SIGAR 14-31 Inspection Report

SALANG HOSPITAL: LACK OF WATER AND POWER SEVERELY LIMITS HOSPITAL SERVICES, AND MAJOR CONSTRUCTION DEFICIENCIES RAISE SAFETY CONCERNS

**JANUARY
2014**

APPENDIX II - COMPARATIVE BUILDING FOOTPRINTS

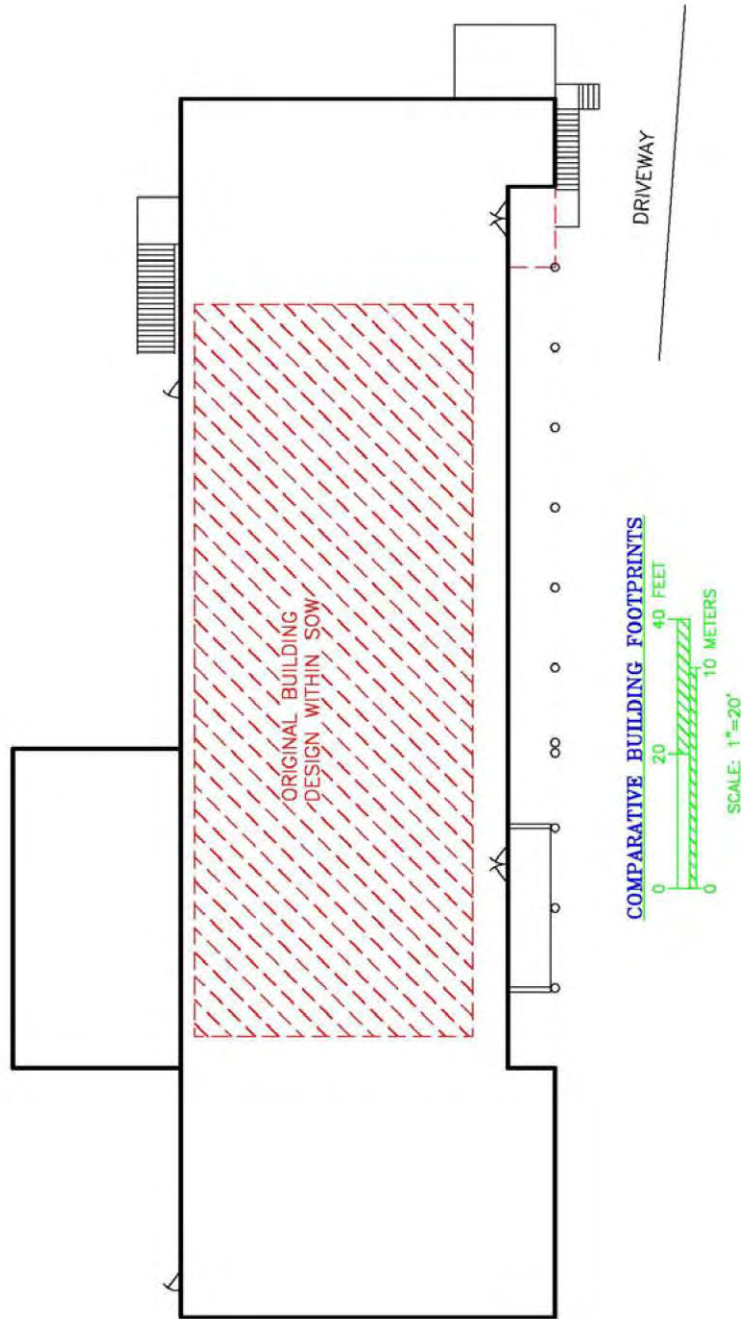
- The original design drawings called for a one-story, 15-room hospital building; a one-story four-stall toilet facility; and a guard shack. However, we found that a two-story building had been built. It was an 18,300-square-foot structure, more than three times larger than the 5,300-square-foot building called for in the original design plans. We could not find any documentation showing that the Bagram Regional Contracting Center contracting officer had modified the contract to approve the two-story building, as was required under the contract.³ According to a Provincial Reconstruction Team record of a meeting with an Afghan Ministry of Public Health official, the Department of State member of the team stated that the Ministry and the provincial government approved the alternate design; however, no documentation exists to confirm that these officials approved the design. The State Department representative also noted that the alternate design was necessary because the hospital's irregularly shaped lot would not accommodate the design called for in the contract documents. However, it is unclear to us why the lot could not accommodate the hospital as originally designed, but could accommodate a facility that had a larger footprint than was called for under the contract. See Appendix II for a comparison of the originally-designed building's footprint and that of the building that was actually constructed.

Note: The outer black lines show the 9,150 square foot footprint of the 18,300 square foot two-story hospital building actually constructed by the contractor. The shaded red box within the black lines shows the relative size of the 5,300 square foot footprint that the Salang hospital would have occupied had it been constructed in accordance with the designs provided for in the contract. It remains a question as to why the lot was inappropriate for the 5,300 square foot building, but suitable for the 18,300 square foot building.
